Reference 22/2795/MRES

Location Land North Of Sidmouth Road (Ceramtec)
Colyton

Proposal Reserved matters application (seeking approval of appearance, landscaping, layout and scale pursuant to outline permission 18/1850/MOUT) for the development of 72 new houses and six B1 use class light industrial units. The proposal includes the discharge of conditions 6, 7, 8, 9, 10, 11, 12, 14, 17, 18, 22, 23, 24 and 25 of the outline planning permission

Committee Date: 30.01.2024
Coly Valley (Colyton)	22/2795/MRES	Target Date: 24.03.2023
Applicant:	Miss Lucy Downs (Housing Developers)	
Location:	Land North Of Sidmouth Road (Ceramtec) Colyton	
Proposal:	Reserved matters application (seeking approval of appearance, landscaping, layout and scale pursuant to outline permission 18/1850/MOUT) for the development of 72 new houses and six B1 use class light industrial units. The proposal includes the discharge of conditions 6, 7, 8, 9, 10, 11, 12, 14, 17, 18, 22, 23, 24 and 25 of the outline planning permission

Figure 1 - Indicative alternative open space layout

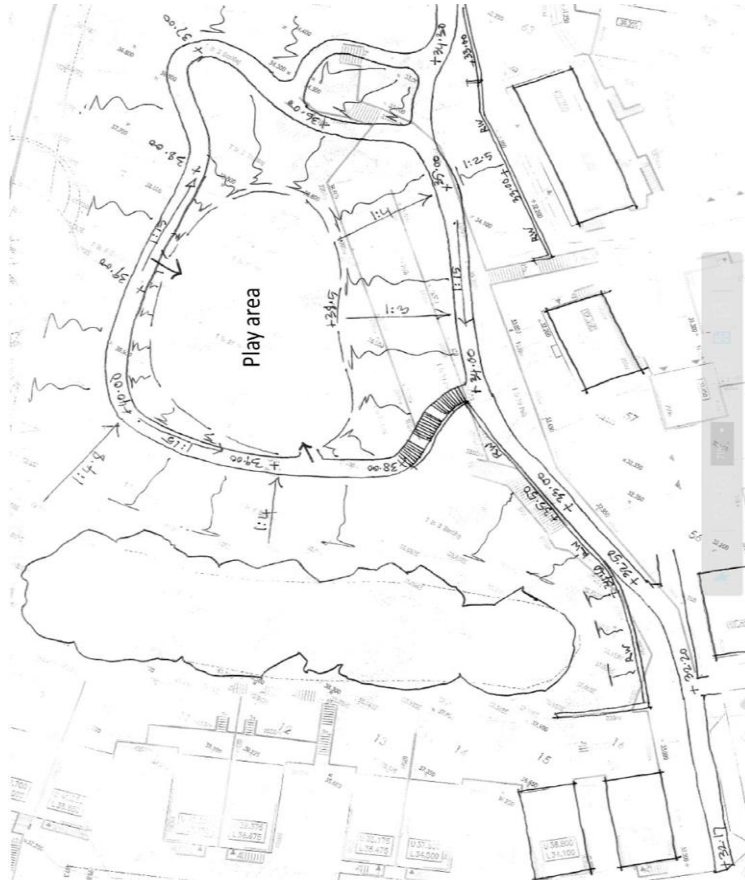
A more naturalistic arrangement designed to a maximum 1:15 path gradient is indicated in figure 1 below, which substantially reduces the height and extent of retaining walls required and provides an un-stepped and more direct pedestrian route connecting from the northern end of the site to the site entrance. Although at a steeper gradient, using tarmac rather than hogginsurfacing as currently proposed would reduce rolling resistance for wheel/ push chair users, countering the increased ramp steepness. It is recommended that the play area and access paths are redesigned along these lines.

Figure 1 - Indicative alternative open space layout

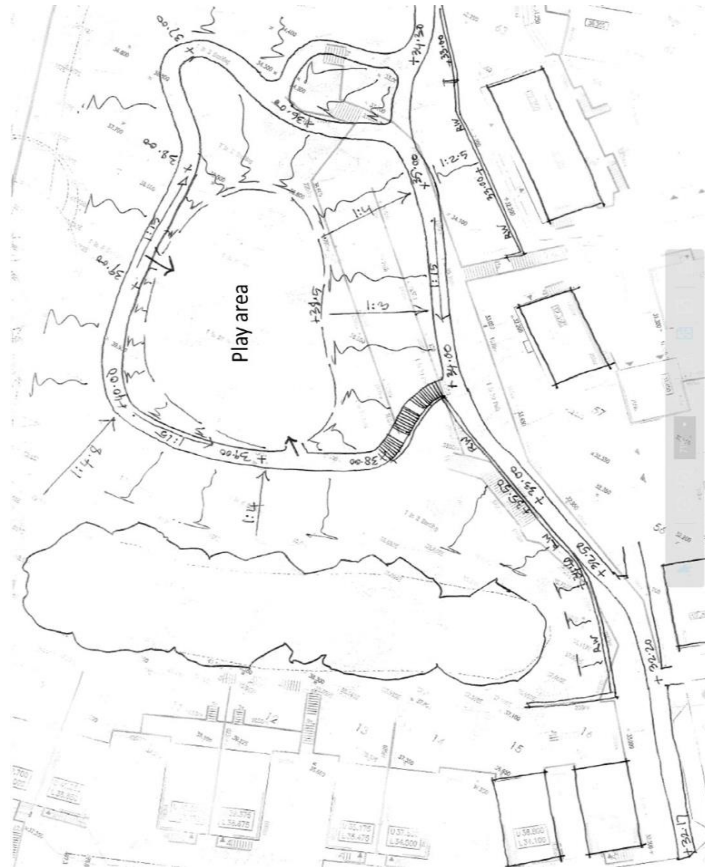
A more naturalistic arrangement designed to a maximum 1:15 path gradient is indicated in figure 1 below, which substantially reduces the height and extent of retaining walls required and provides an un-stepped and more direct pedestrian route connecting from the northern end of the site to the site entrance. Although at a steeper gradient, using tarmac rather than hoggin surfacing as currently proposed would reduce rolling resistance for wheel/ push chair users, countering the increased ramp steepness. It is recommended that the play area and access paths are redesigned along these lines.

It is noted that to the north of plot 16 proposed guard railing for the retaining wall does not follow the line of the wall and should be adjusted so it does.

2.2 Play area (refer layout, hard landscape and enclosure plans)

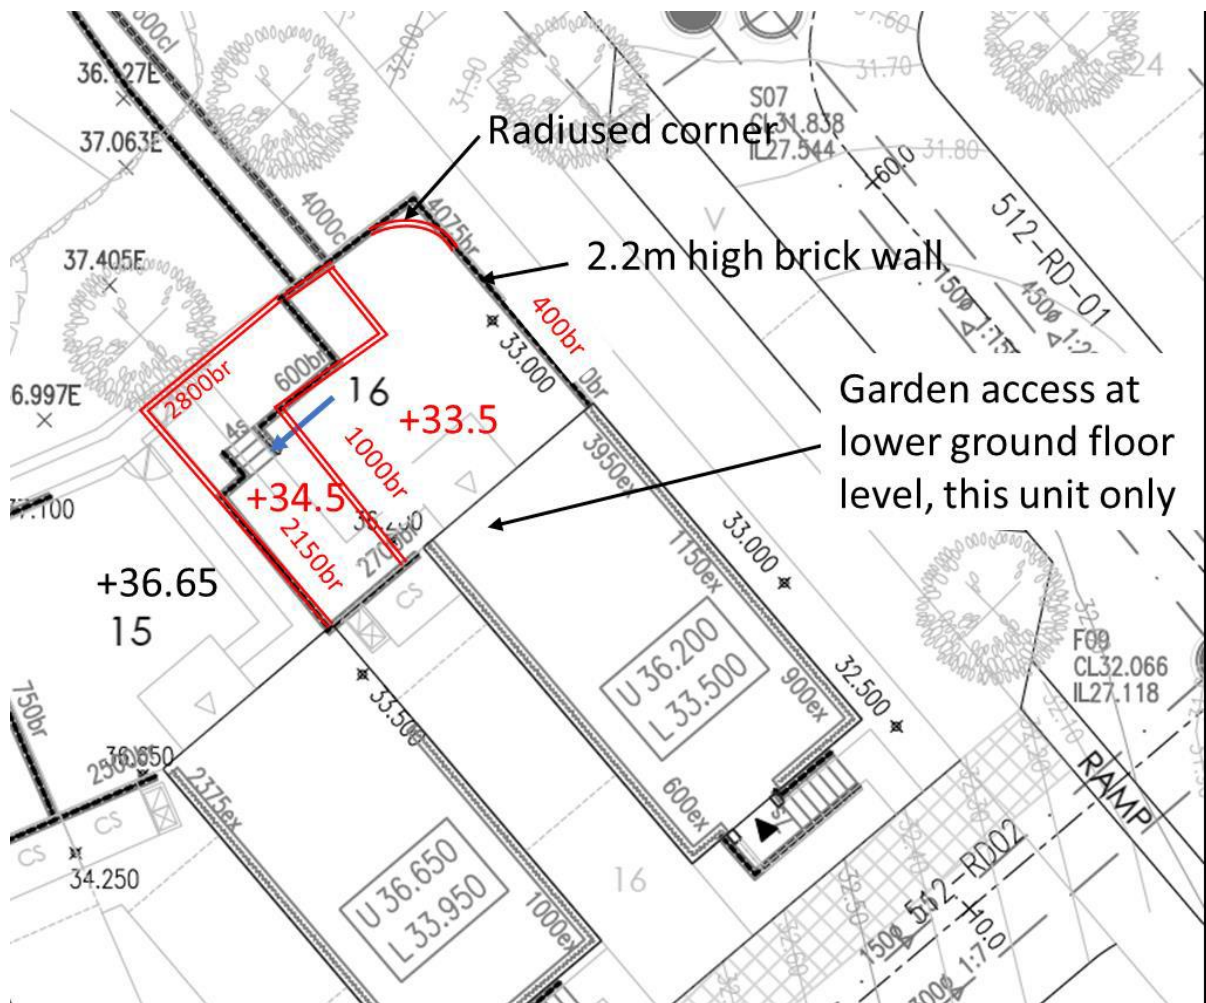
- a) I have previously made suggestions about the proposed access ramp to the play area which I still consider to be an over-engineered solution.
- b) With regard to the play area itself it is understood final design of the play area is subject to local consultation. Notwithstanding this, the bow top railings proposed around the play area seem unnecessary and result in a lot of wasted space on the surrounding banks outside of it. By amending the fencing as per overmarked plan

below the play area can be substantially increased in size allowing free play over the surrounding banks and reducing the amount of fencing significantly.

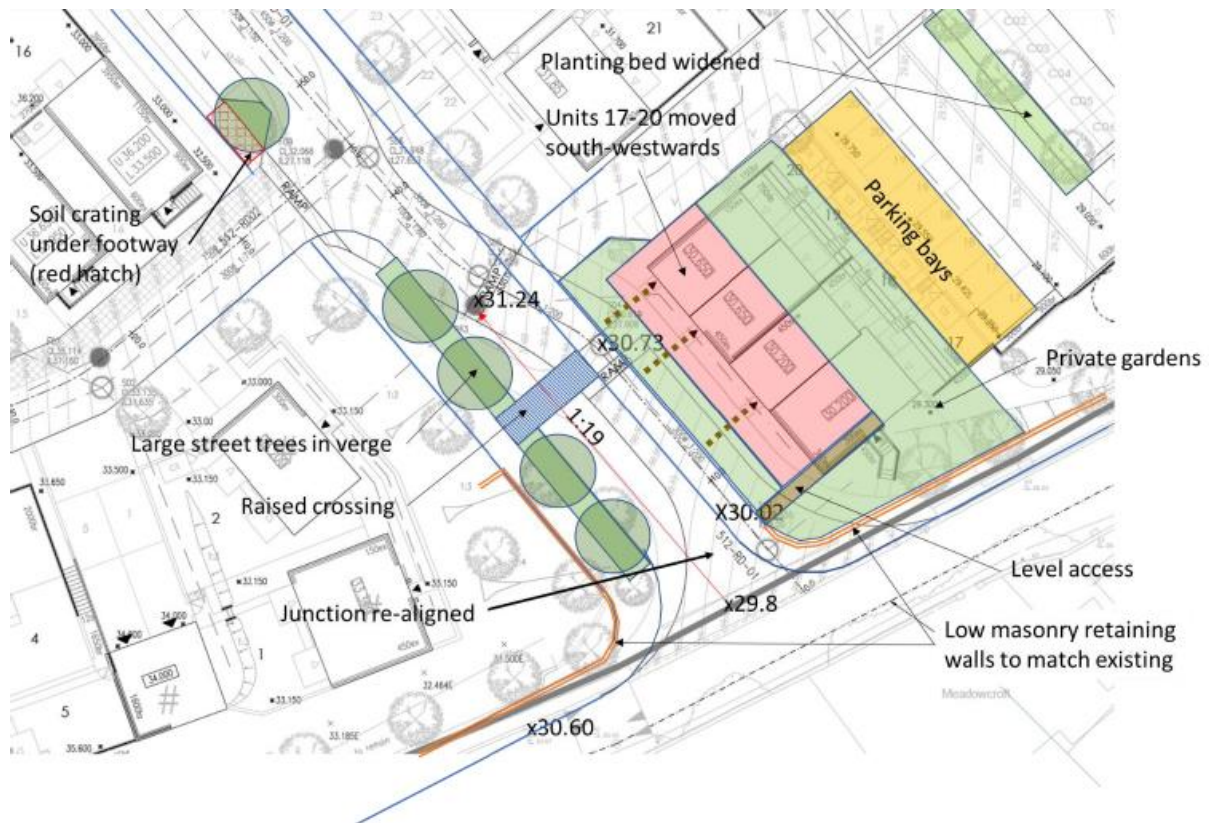
a) At a recent design meeting with the applicant concerns were raised regarding the alignment of the main entrance road and it was understood an alternative layout would be considered moving the entrance slightly westwards along Sidmouth Road. This has not been provided but is considered both feasible and desirable, creating more space within the commercial area courtyard, reducing the openness of the site entrance which is uncharacteristic in the setting of Colyton and reducing the extent of 'left over space' to the west side of the junction (refer overmarked plan extract below).

The junction radii should also be tightened to be more in keeping with Colyton street form and to reduce the crossing distance for pedestrians.

Figure 2. Proposed routes to the play area, with and without steps
Footpath materials and retaining structures

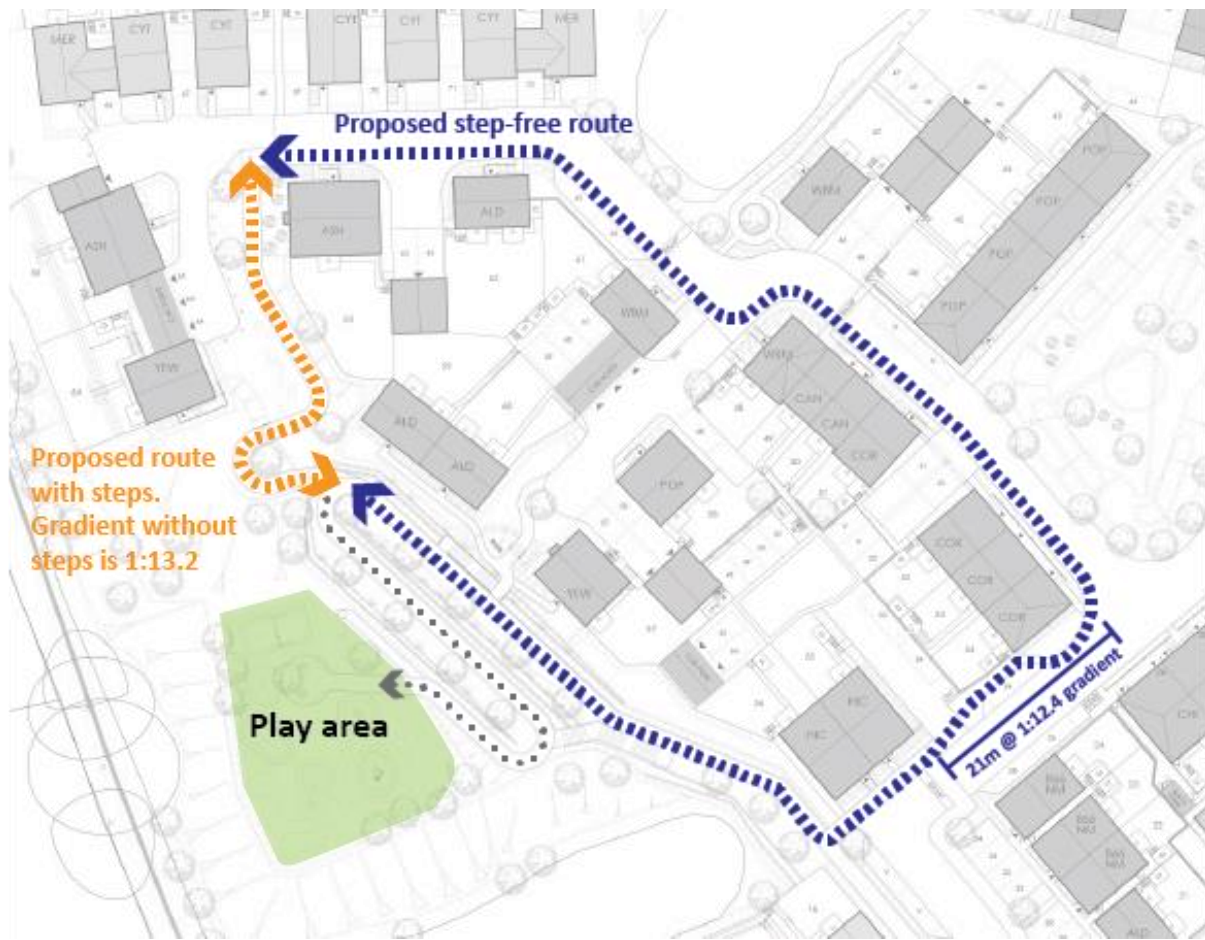
- o The rise of the section with steps from plot 63 to where it joins the main path is 4.3 metres over a distance of 56.9 metres. Without the steps this would give a gradient of 1:13.2.
- o From the start of the path next to plot 63 to the play area entrance is roughly 120 metres. The distance between the same two points but using the road is 305 metres increasing journey distance by 185 metres;
- o The walk along the road to the path next to plot 56 includes a section that rises 2.1 metres over a distance of 26.1 metres giving a gradient of 1:12.4.

People unable to negotiate steps have to use the road to get to the base of the path next to plot 56 for step-free access. The steps are included to avoid a gradient steeper than guidance would suggest but results in a perverse outcome where the journey is longer, and in some parts steeper. The steps are likely to be more of a hazard than a sloping path due to trips and falls. Removing the steps and increasing the length of this section by a small amount to include landings would allow a shorter step-free route with a lower gradient than the current one.
